## 3.2.3 Residential amenity

## Dual-aspect apartments in Buildings A, C and D

Proposed apartment layout in Building A. Section below

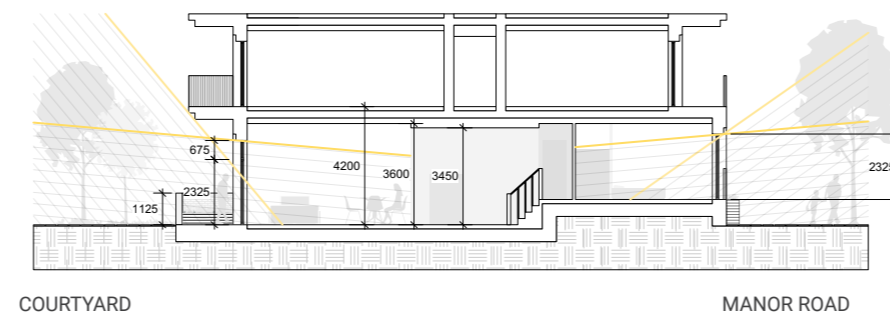
In response to comments made at the MDA review regarding apartments along Manor Road, the apartments at ground floor have been redesigned to become dual-aspect. These apartments now open onto Manor Road. Buildings C and D have also be redesigned to include these dual-aspect apartments on the ground floor.

Proposed apartment layout in Building A. Internal view on page 30.

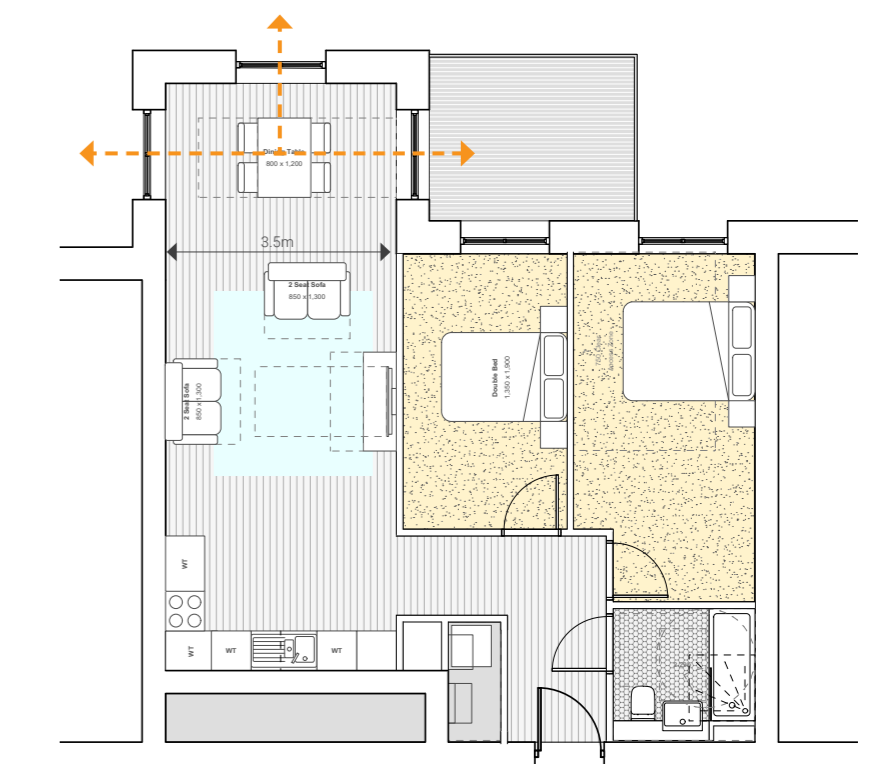
Particular examples of where the scheme has been redesigned includes Building A where two single-aspect north-facing homes on the previous scheme have been replaced by apartments with triple- aspect projecting bay windows.

Amended proposed basement layout

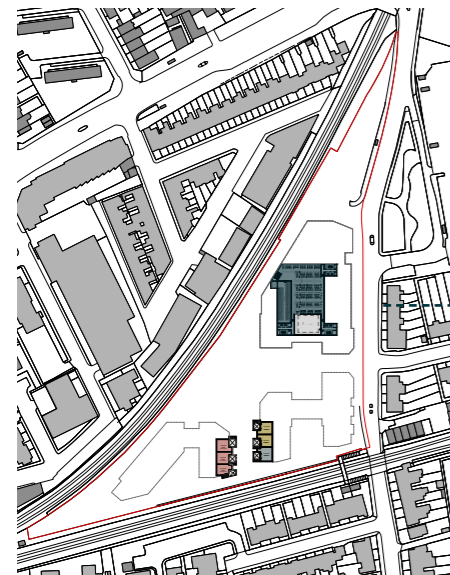
In consultation with TfL residential bike stores / refuse stores and plant rooms have been relocated from the basement to ground floor. The location of these stores has been carefully selected to take up less desirable areas for homes (i.e. along the residential access road).

The size of the basement has been revised to provide plant room space for cold water tanks only.
